G0.10 --- CODE ANALYSISREVISED SUBMITTAL - PL20220623

G0.10 --- CODE ANALYSISORIGINAL SUBMITTAL - PL20220623

The Amble

The Amble Steamboat, CO

A3.00-A3.01 --- BUILDING SECTIONS

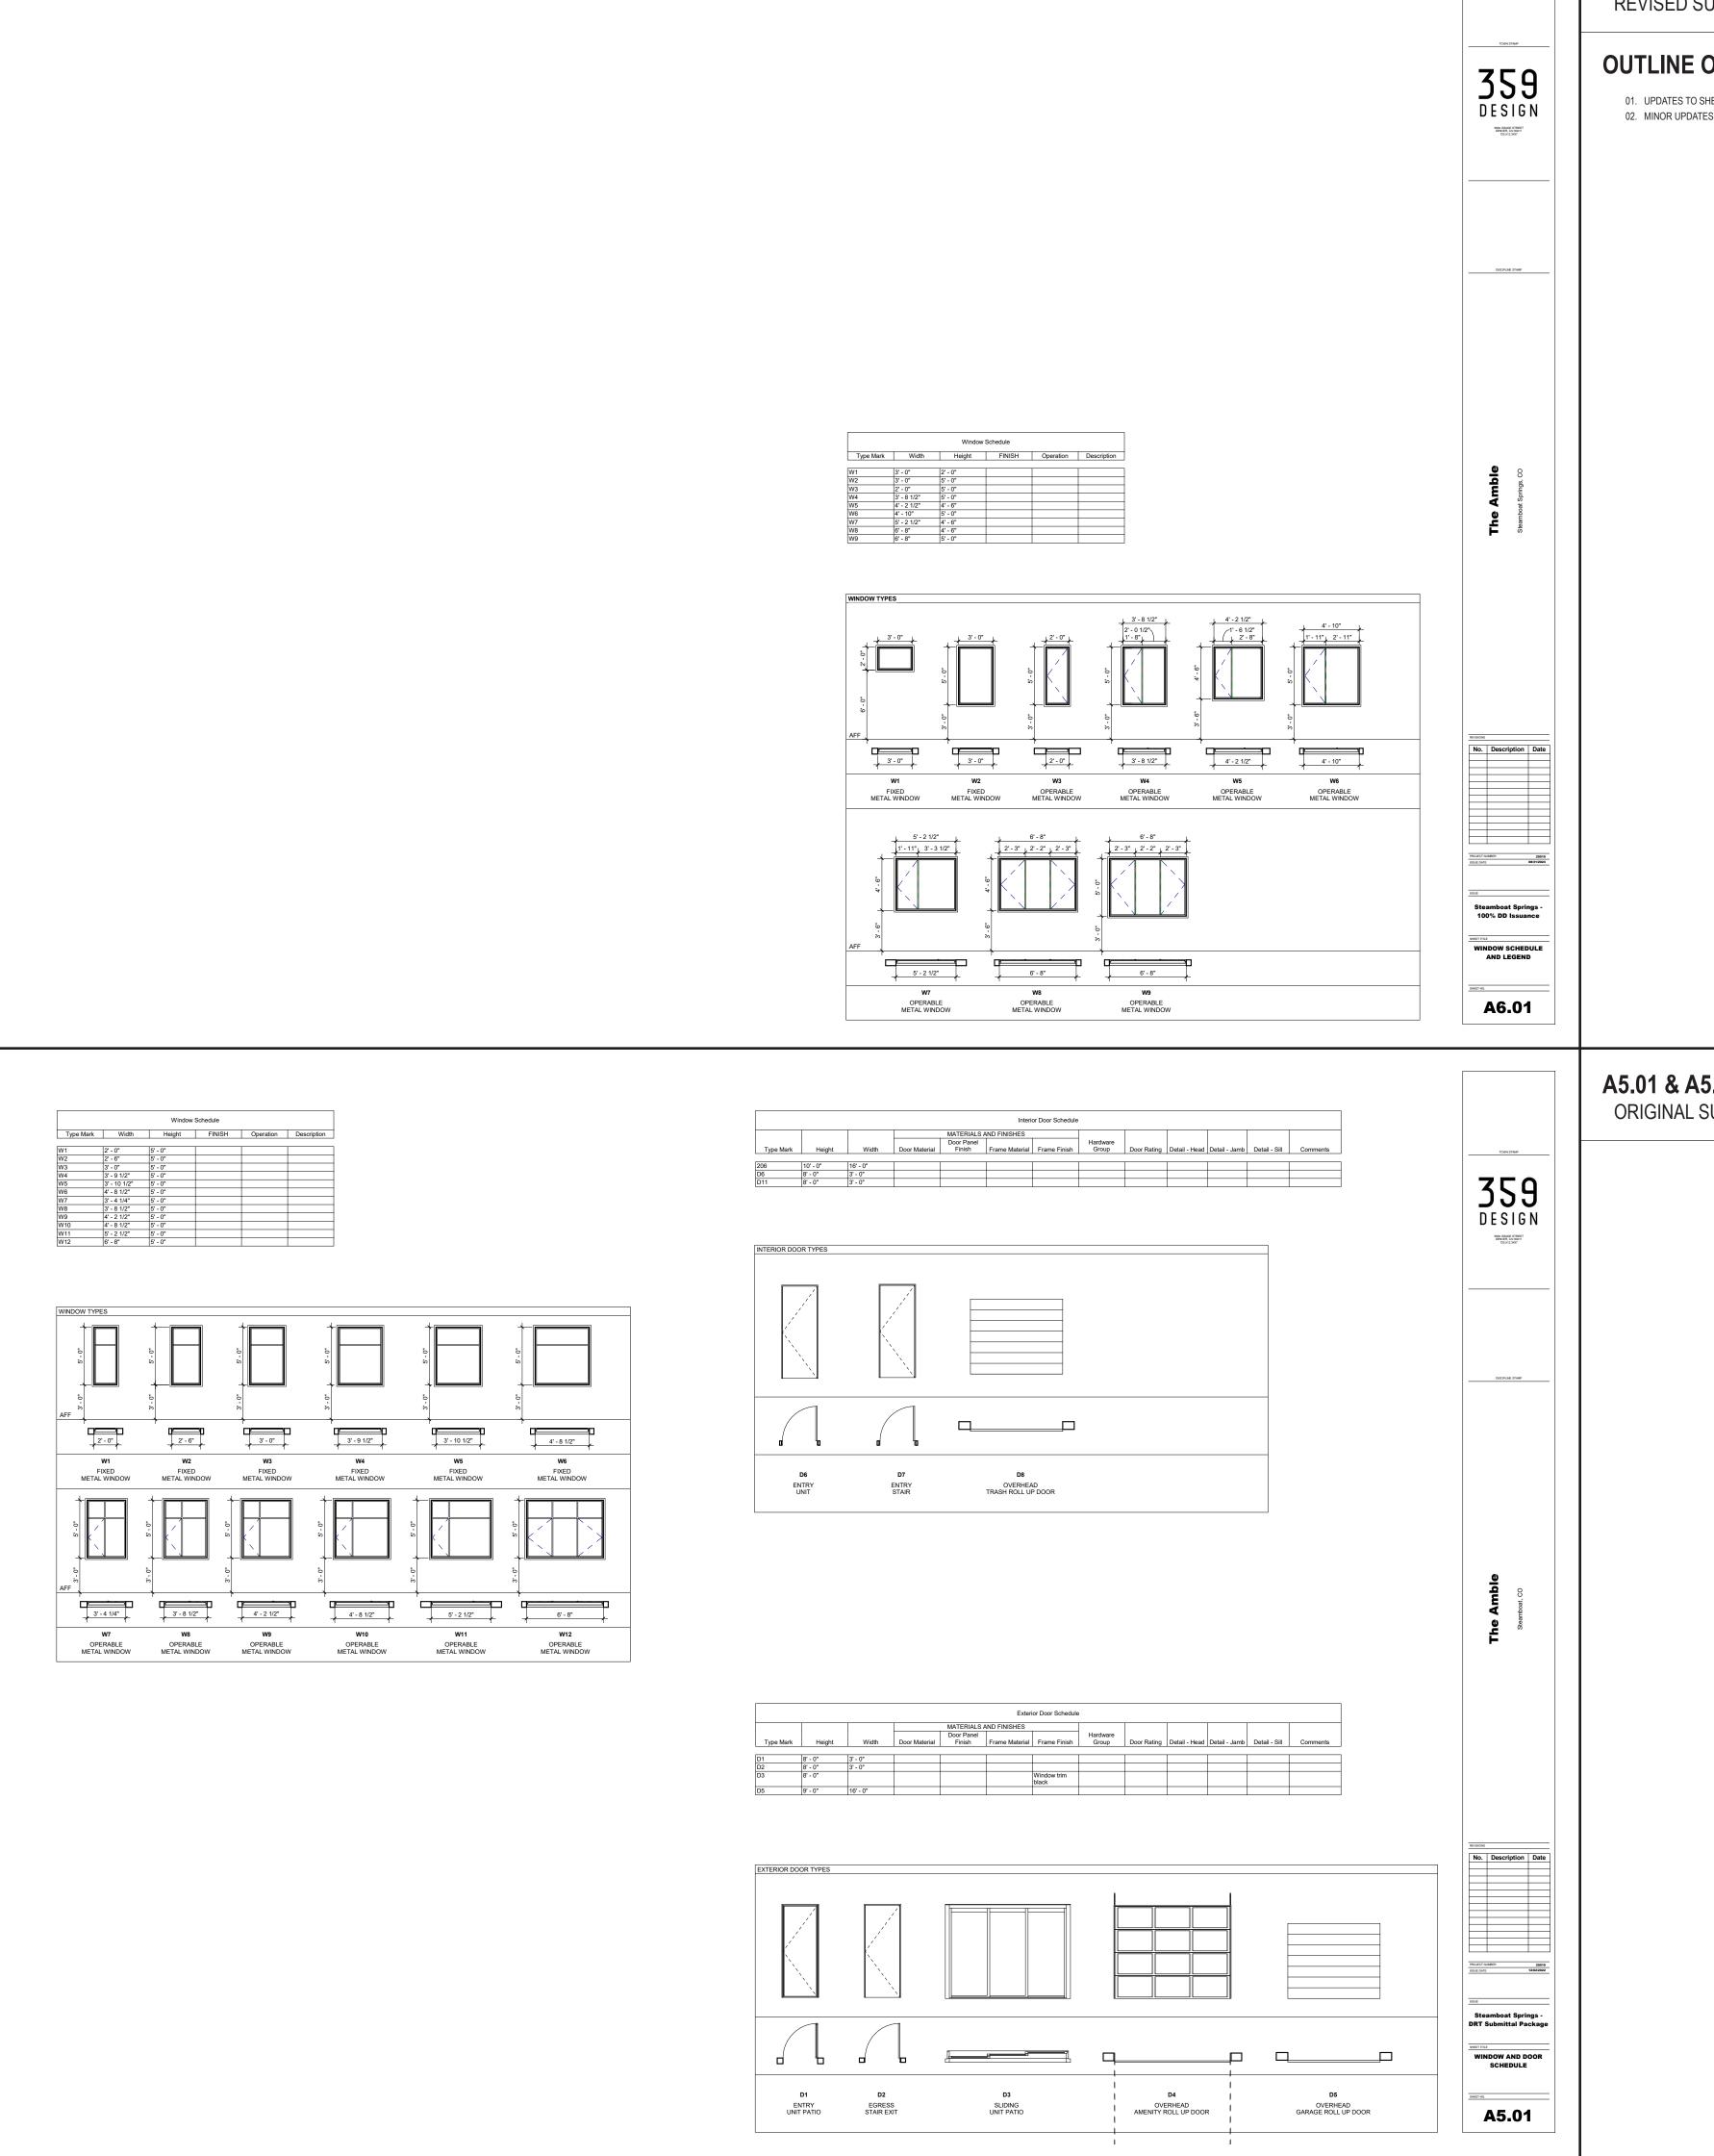
01. MINOR UPDATES TO OVERALL FLOOR-TO-FLOOR HEIGHTS.

A7.02 --- BUILDING HEIGHT REVIEW REVISED SUBMITTAL - PL20220623

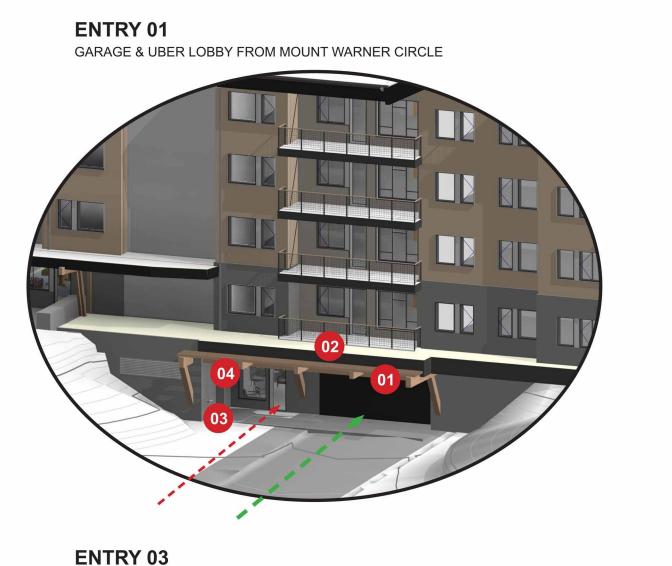
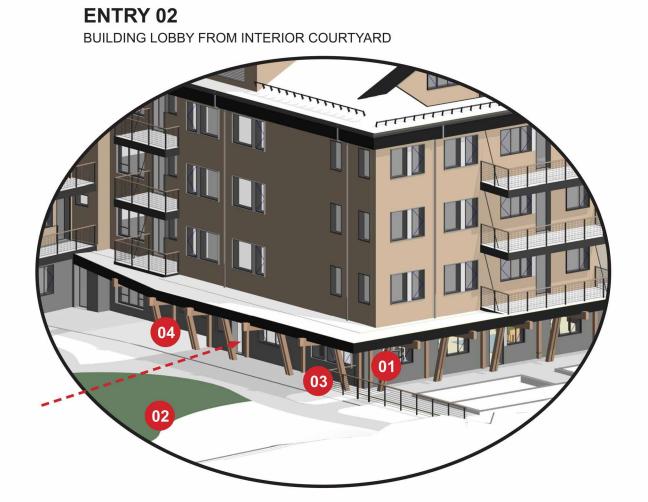
01. MAXIMUM BUILDING HEIGHT CHANGED FROM 62' - 9 1/4" TO 62' - 1 1/2" 02. MAXIMUM BUILDING HEIGHT REVIEW RE-CALIBRATED TO MATCH DESIGN UPDATES

03. SHEET NUMBER UPDATED FROM A6.01 TO A7.02.

A7.03 --- BUILDING ENTRY EXHIBIT REVISED SUBMITTAL - PL20220623

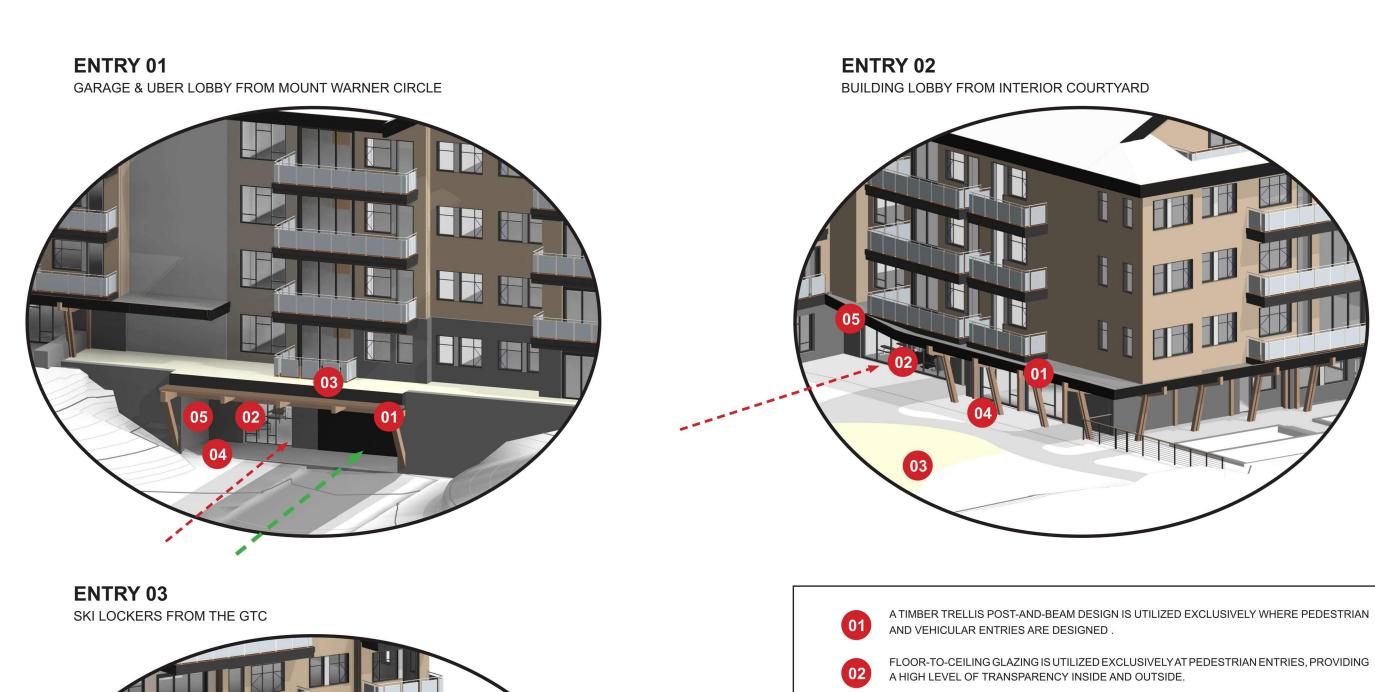
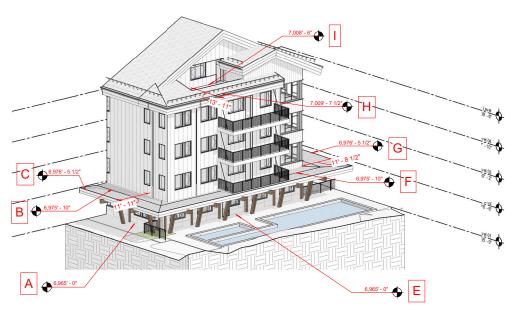
- 01. GRAPHICS UPDATED TO MATCH THE LATEST DEISGN.
- 02. LOBBY WINDOWS UPDATED FROM FLOOR-TO-CEILING GLAZING TO GLAZING WITH A 3' 0" SILL. WHILE THE REPETITION AND SPACING OF THE WINDOWS IS STILL DIFFERENT FROM THE UNITS, THE LANGUAGE NOTED
- IN THE LEGEND IS UPDATED TO REFLECT THIS CHANGE.

03. SHEET NUMBER UPDATED FROM A6.02 TO A7.03.

A7.04 --- BUILDING STEP EXHIBIT REVISED SUBMITTAL - PL20220623

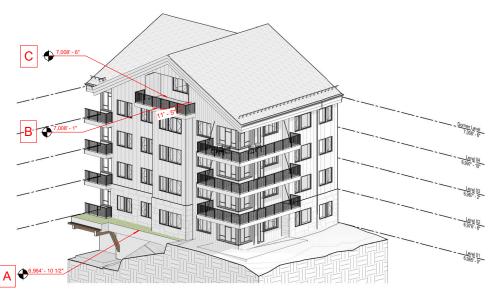
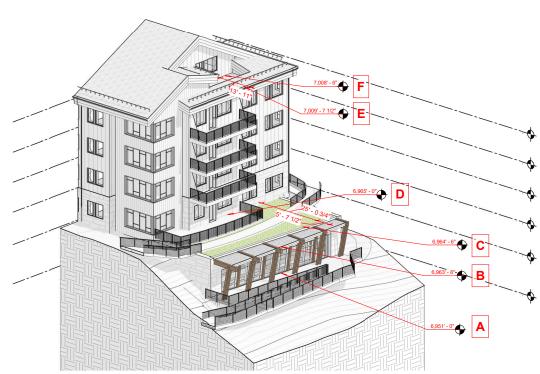
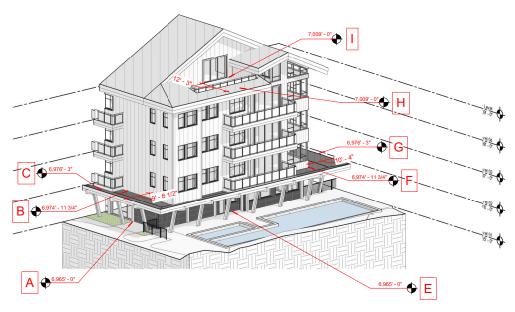
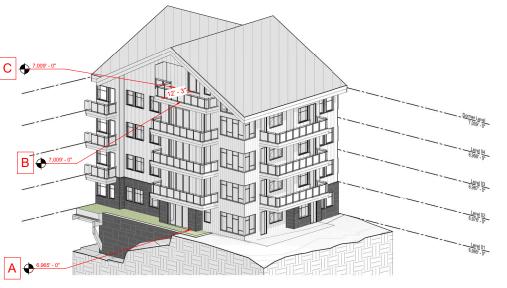
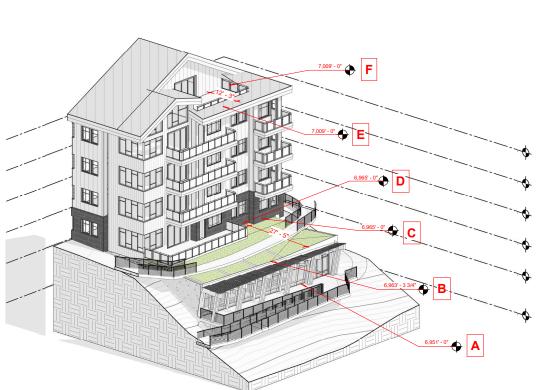
01. WHILE THE BUILDING STEP DESIGN REMAINS THE SAME, THE GRAPHICS AND EXHIBIT TABLES HAVE BEEN

UPDATED TO REFLECT THE LATEST DESIGN.

02. SHEET NUMBER IS UPDATED FROM A6.03 TO A7.04.

C3.01-C.700 --- CIVIL PACKAGE REVISED SUBMITTAL - PL20220623

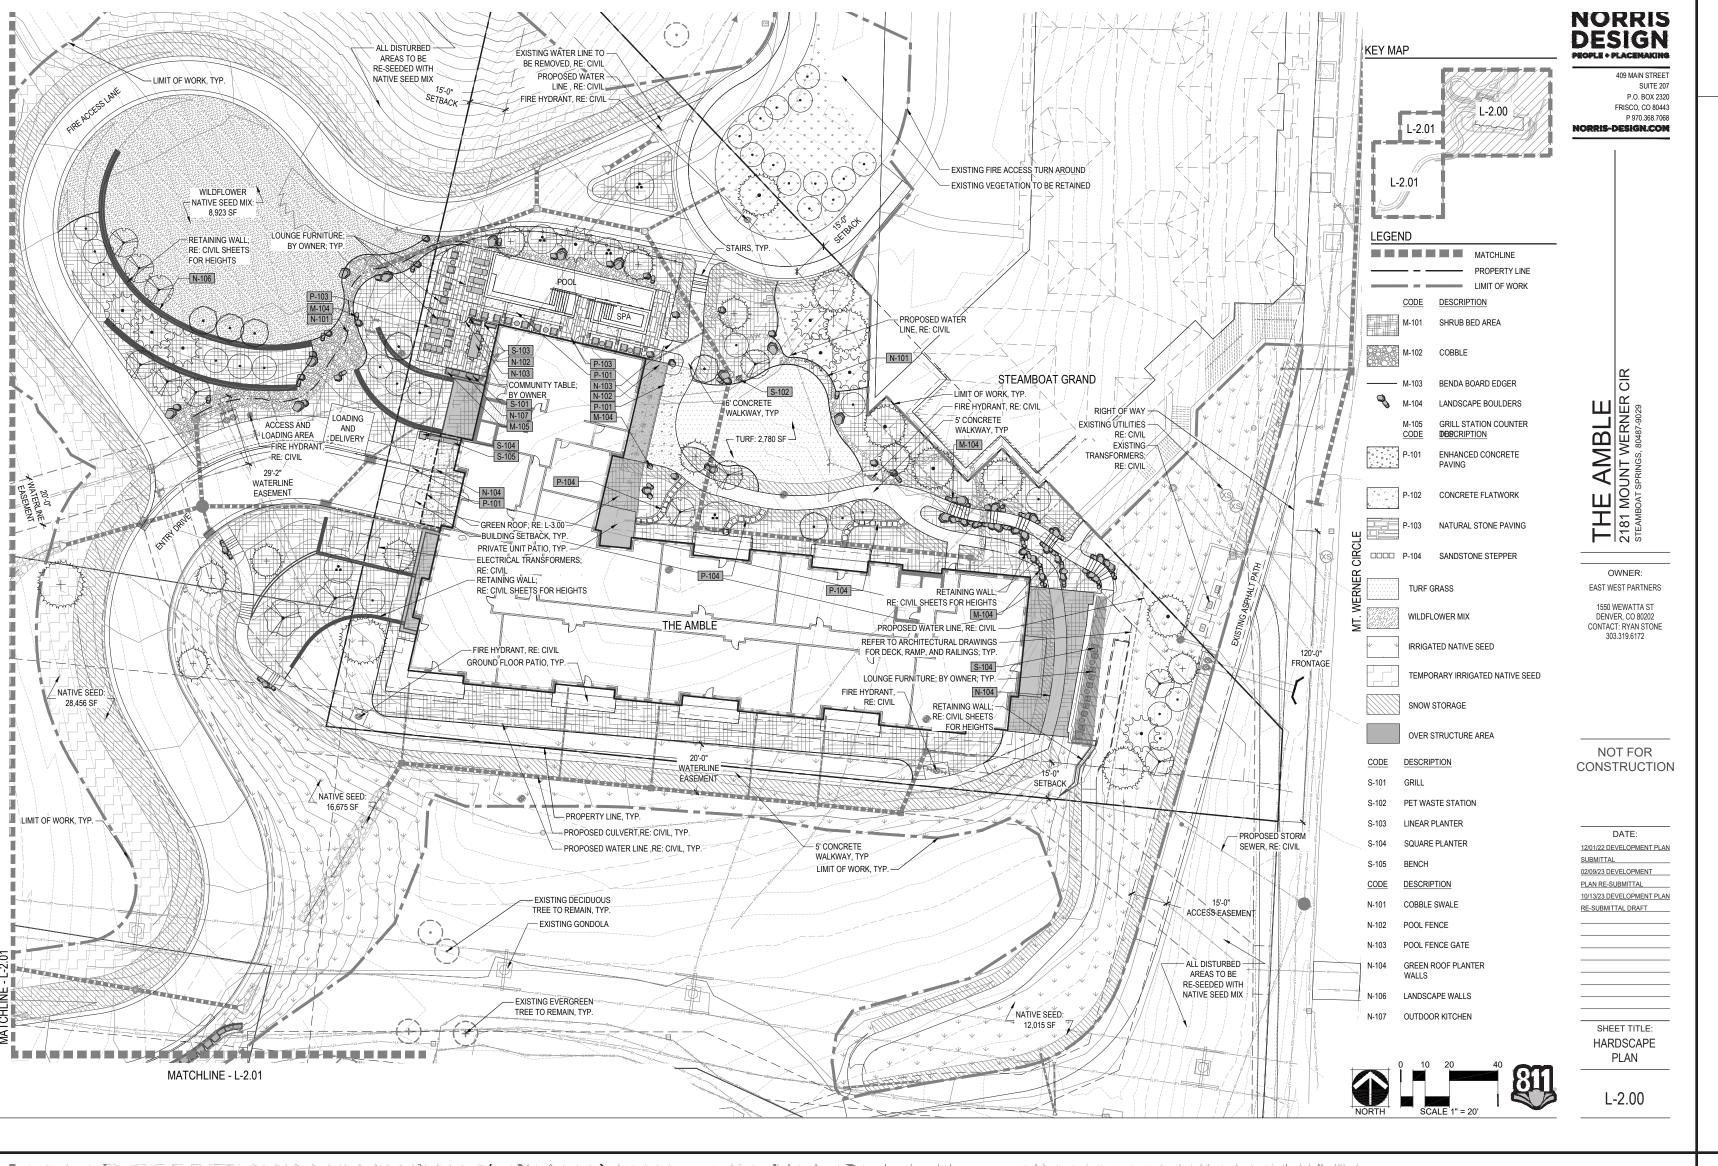
- 01. THE PRIVATE WATER ENTRY HAS BEEN RELOCATED TO THE NEW WATER ENTRY ROOM AT THE NW CORNER
- OF THE PROPOSED BUILDING (RE: ARCHITECTURAL DRAWINGS A1.00 AND A1.10.1).

02. FIRE STANDPIPES ADDED TO THE EAST SIDE OF THE SITE, TO BE ACCESSED FROM THE GTC.
- 03. MINOR UPDATES TO SITE WALLS TO THE SOUTH OF THE ENTRY, PRIMARILY TO PROVIDE A LOCATION FOR THE
- TRANSFORMERS AS PREVIOUSLY REVIEWED.

04. MINOR UPDATES TO THE DRAINAGE PIPES AT THE ENTRY.
- 05. MINOR UPDATES TO THE BUILDING FOOTPRINT (RE: ARCHITECTURE).
- 06. APPROVED PRELIMINARY PLAT CHANGES SHOWN.
